### AMENDMENTS TO THE DRAWINGS

### SUBMISSION OF FORMAL DRAWINGS

FIG. 1

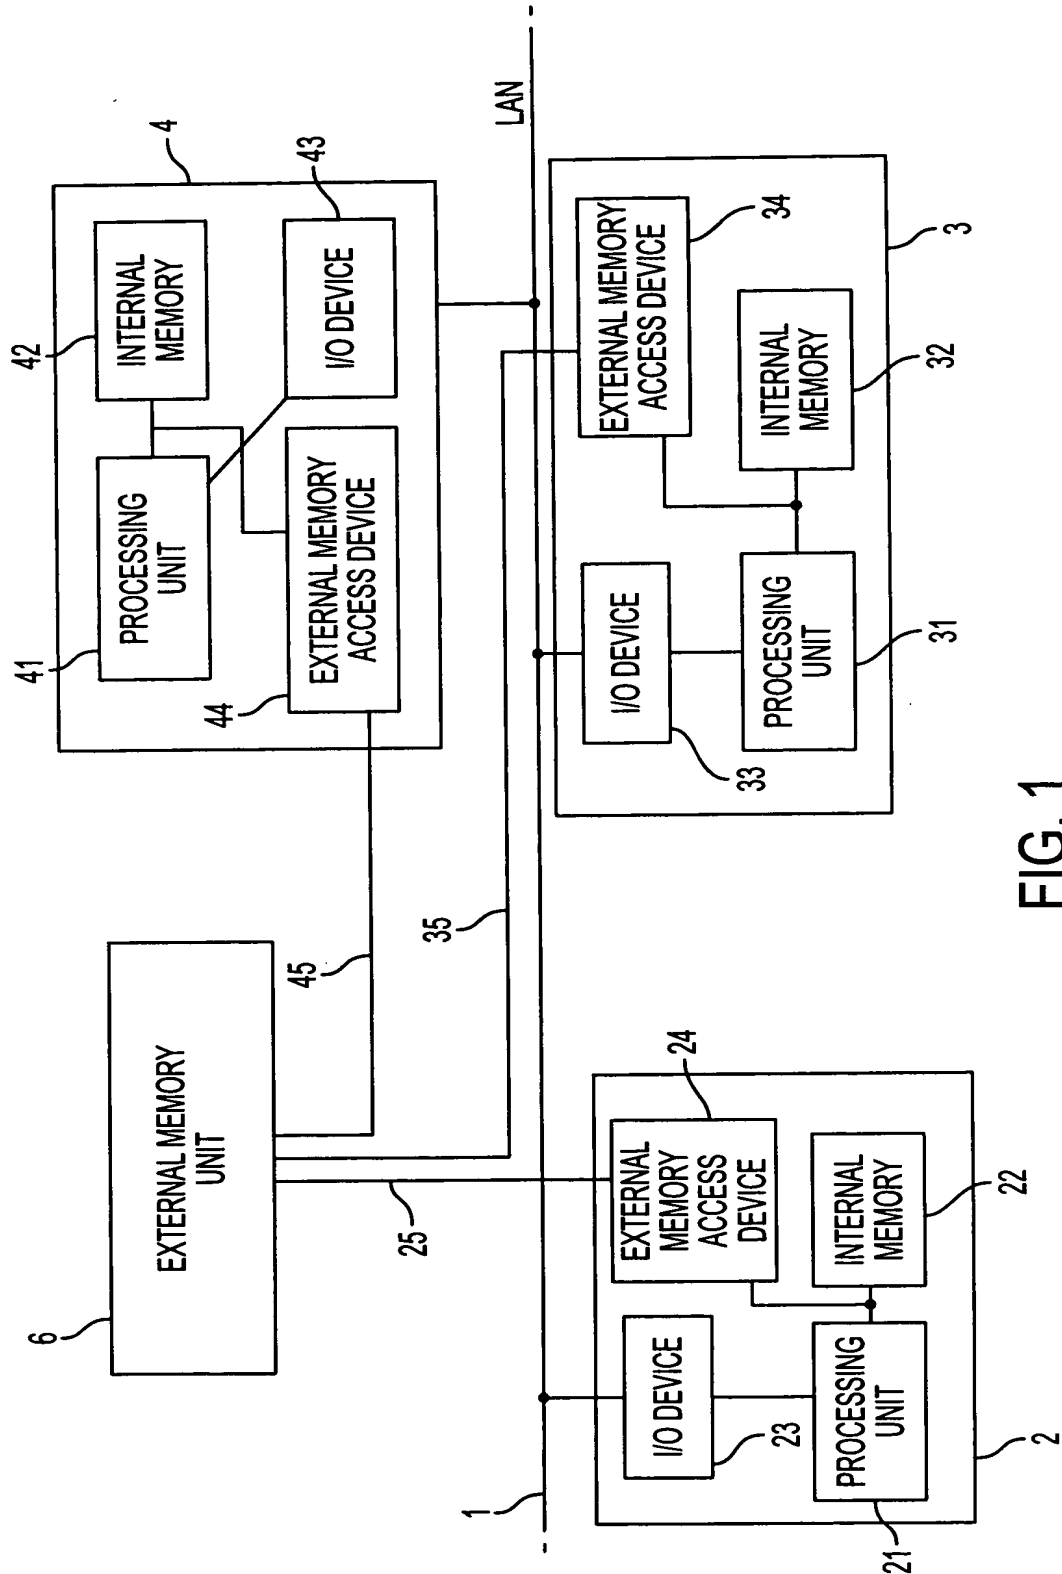
In this response, it is proposed to amend Figs. 1 and 2 in a manner wherein the objections to the drawings set forth in paragraphs #1, 2 and 3 of this Office Action, are overcome. More specifically, the lead line associated with numeral 43 as been changed to lead to the I/O DEVICE included in the machine which has had the numeral 4 and associated lead line added thereto, and numeral 32 associated with the I/O DEVICE included in machine 3, is changed to 33.

FIG. 2

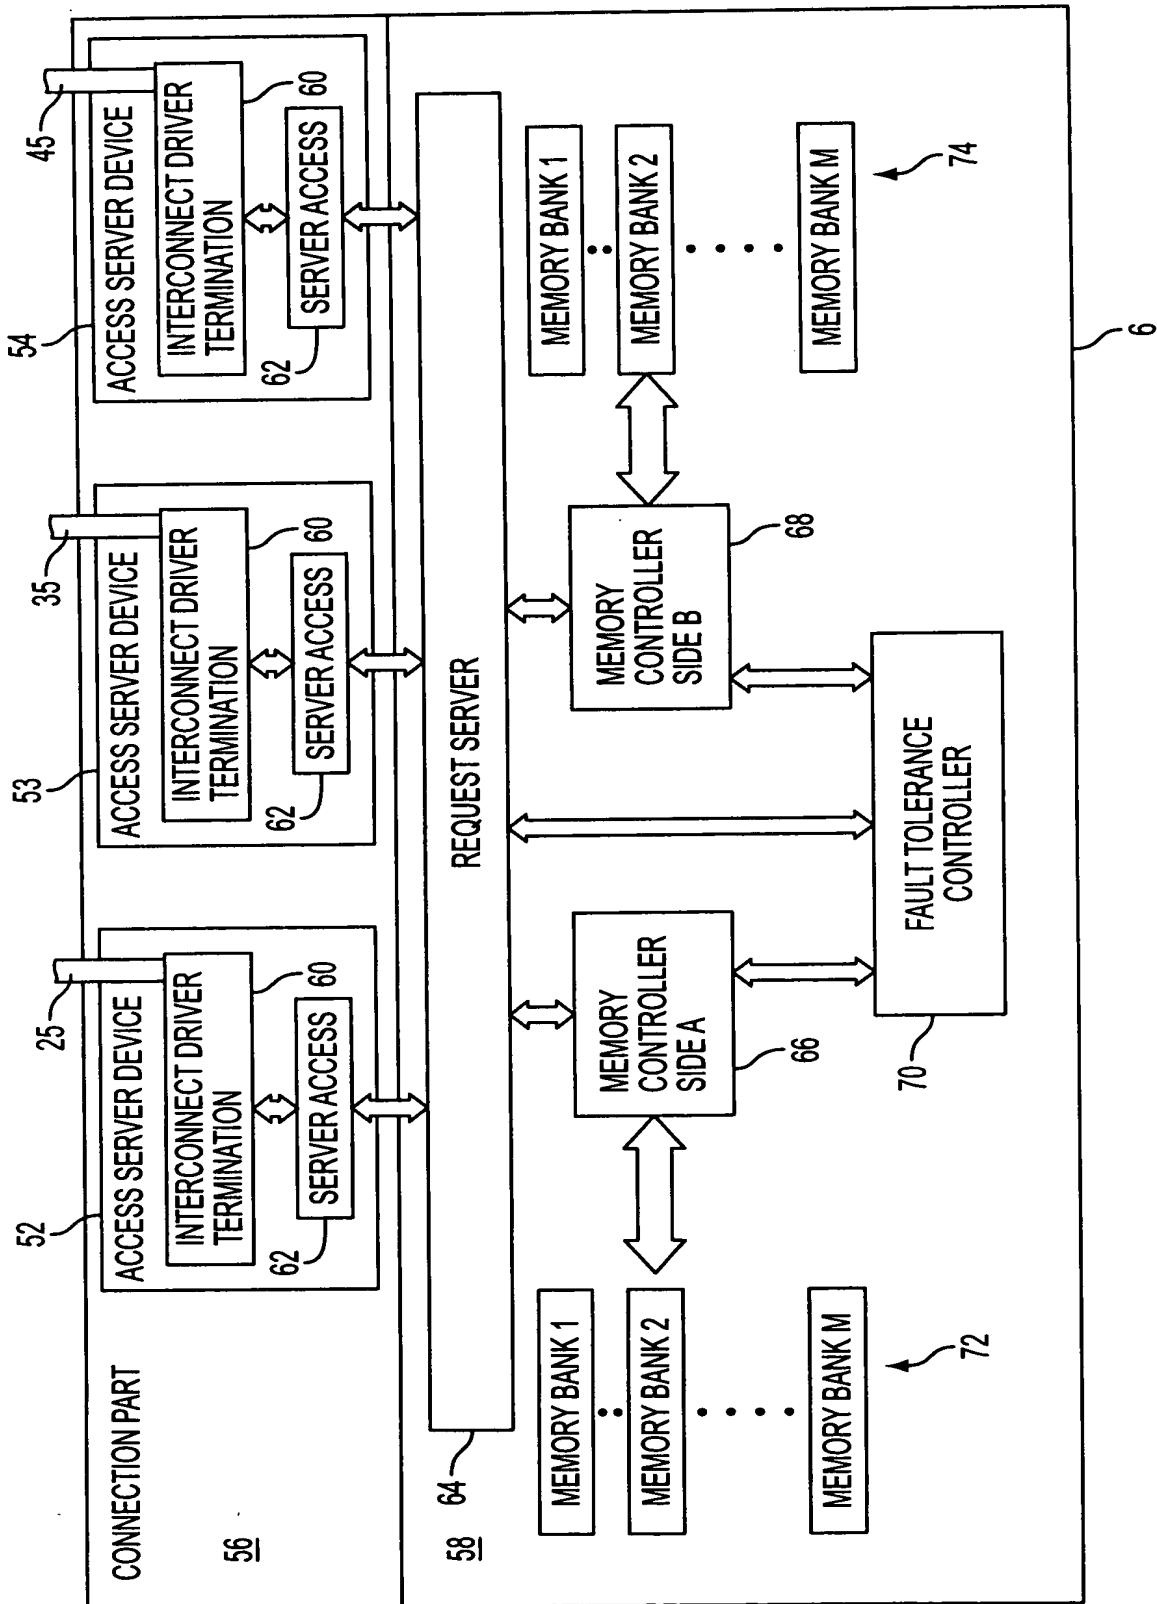
In Fig. 2, numerals 60 and 62 have been respectively added to denote the INTERCONNECTION DRIVER TERMINATION and the SERVER ACCESS blocks in each of the ACCESS SERVER DEVICES 52, 53, 54, and the spelling of SERVER in the "SERVER ACCESS" block (in ACCESS SERVER DEVICE 52), has been corrected.
